FURTHER SUBMISSION IN SUPPORT OF, OR IN OPPOSITION TO,  
SUBMISSION ON PUBLICLY NOTIFIED PROPOSED PLAN CHANGE  
TO CENTRAL OTAGO DISTRICT PLAN

This is a further submission in support of (or in opposition to) a submission on proposed Plan Change 13 to the Central Otago District Plan.

The Assessment of Effects on the Environment (AEE) prepared by Brown and Company Planning Group, dated 1 March 2018, make specific reference to effects of the proposed development in relation to traffic, and further note that effects of the plan change on associated transportation issues are addressed in the Transportation Assessment report prepared by Carriageway Consulting, dated 14 December 2017.

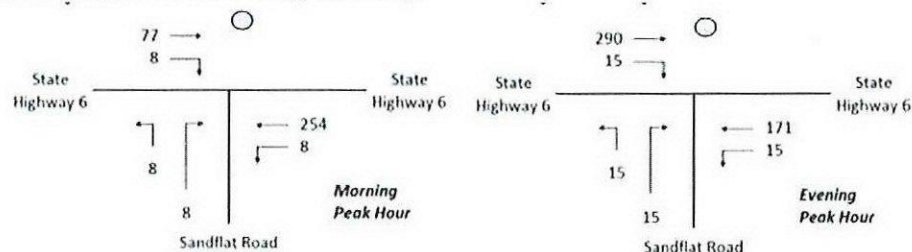
It should be noted that this conclusion is based on there having been four crashes in the subject area between 2012 and 2016 (an average of once crash per year) and that this is based on the current traffic volumes, with Sandflat Road and Cemetery Road currently experiencing “low traffic flows”. The Transportation Assessment has not determined whether a ~50% increase in traffic volumes is likely to result in a 50% increase in the incidence of crashes in the area. In fact, the Transportation Assessment is conveniently silent on the effects of an increase in traffic volume on the incidence of crashes in the area.

Figures 4 and 5: Peak Hour Traffic Flows at the State Highway 6 / Sandflat Road Intersection

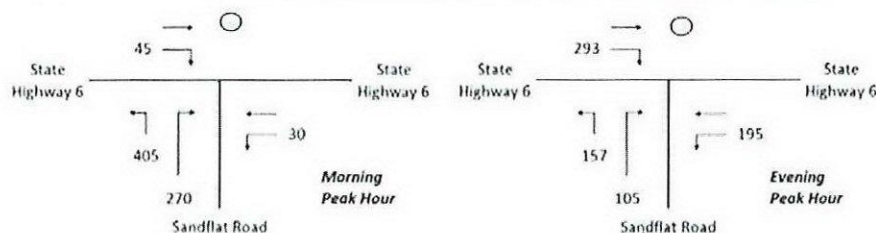
The following images, taken from the Transportation Assessment, provide an easy visual representation of the likely increase in traffic movements at SH6/Sandflat Road intersection. The top image is the modelled current peak hour traffic flows at the intersection, and the lower image is the modelled peak hour traffic flows following the proposed development. The yellow dots denote the relative location of my driveway.

These images show over 33 times more traffic exiting north from Sandflat Road during the morning rush hour as a result of the proposed development, and 7 times more traffic existing north from Sandflat Road during the evening rush hour. The Transportation Assessment has also modelled the wait time of vehicles wanting to turn out of the northern end of Sandflat Road following the proposed development. The modelling indicates that the average wait time will increase significantly.

In summary, the Transportation Assessment indicates that there will be somewhere between 7 (evening) and 33 (morning) times more traffic sitting at the top of Sandflat Road waiting to turn onto SH6, and that these cars will be waiting there for between 46% (morning) and 77% (evening) longer. As described earlier in this submission, drivers and passenger waiting at the end of Sandflat Road to turn onto SH6 can look straight up my driveway, and their headlights shine straight into my living room. The proposed increase in the volume of traffic and the increase in the wait time of this traffic will, therefore, result in adverse effects on my privacy and my sense of security. This will also most certainly impact on my ability to enter and exit my own driveway too.
